March 10, 2020

RE: Lot 35 Block 6 SAD 227 7904 Kibo NW Unser Cliffs Subdivision Grading and Drainage Plan Engineers Stamp Date 3/6/20 (E10D056)

RE: Lot 35, Block 6, Volcano Cliffs No. 2 Subd, SAD 227 (E10D056) 7904 Kibo dr NW

ENGINEER'S SEAL	Title: LOT 35, BLOCK 6, -VOLCANO CLIFFS NO. 2	DRAWN BY DATE
	Richard Dourte P.E. #10854	CONCEPTUAL GRADING AND DRAINAGE PLAN <i>RHD Engineering, LLE</i> 4305 Pumple Sage Ave. NW <i>ALBUQUERQUE, NM 87120</i> (505) 288-1621	dwg SHEET # X of X JOB #

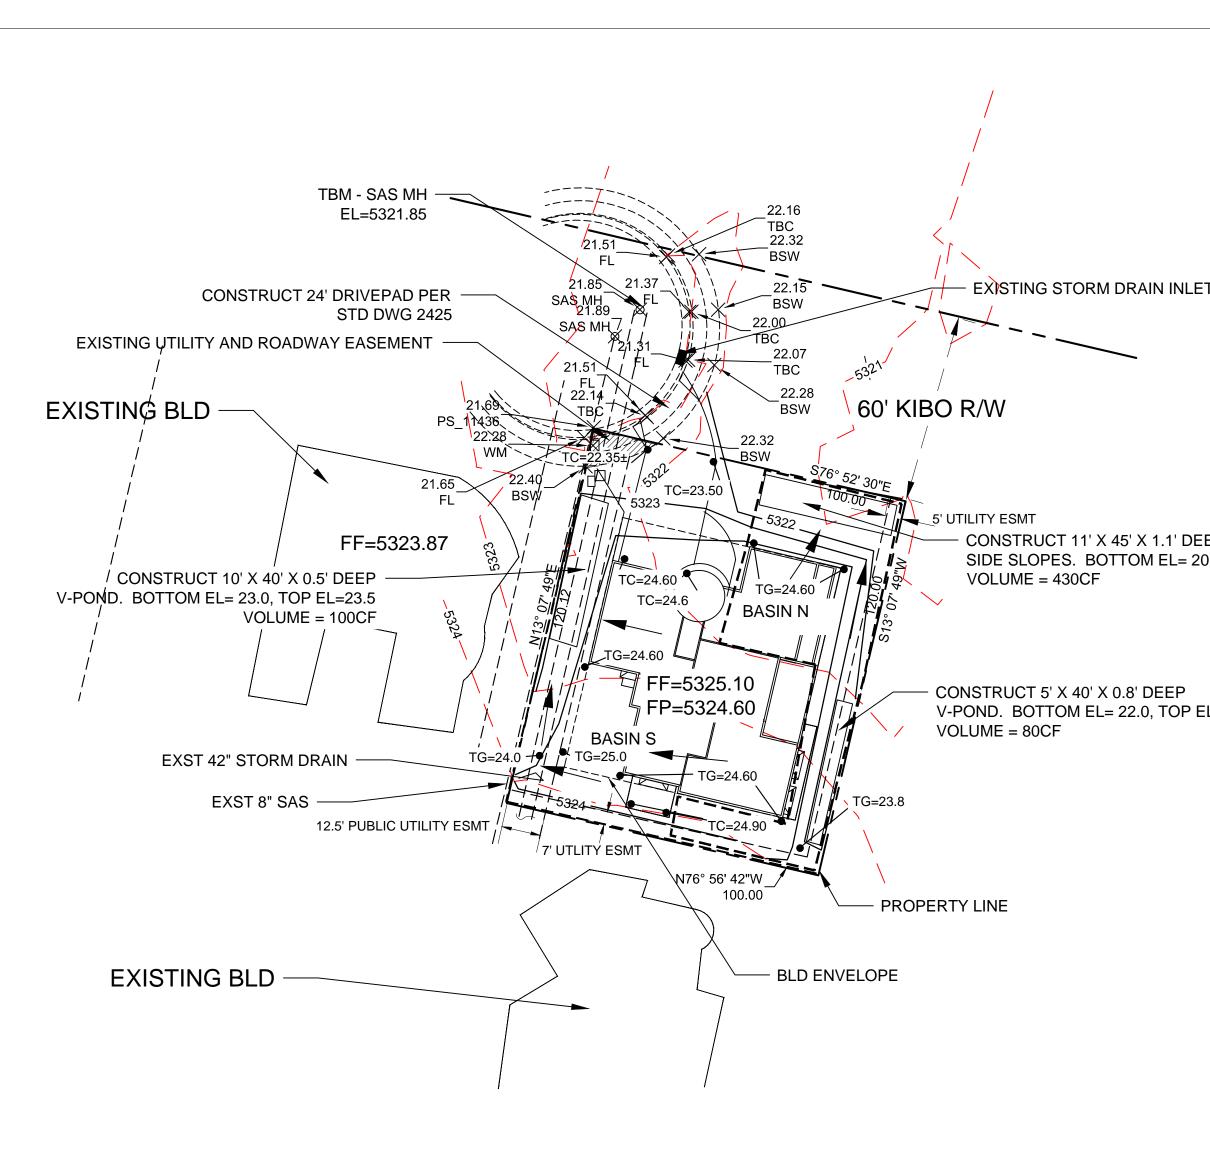
Based upon the information provided in your submittal received 3/9/20, this plan is approved for Grading Permit. Please inform the builder/owner to attach a copy of this approved plan and letter into the construction sets in the permitting process prior to sign-off by Hydrology.

> Reiterate to the Owner/Contractor that a separate permit for a garden/retaining wall must be obtained, with the approved G&D plan. Also inform the contractor to use lumber, asphalt millings or any type of material other than dirt, to ramp over the curb stone.

Prior to building permit approval a pad certification will be required.

Prior to Certificate of Occupancy release, Engineer Certification per the DPM checklist of this plan will be required.
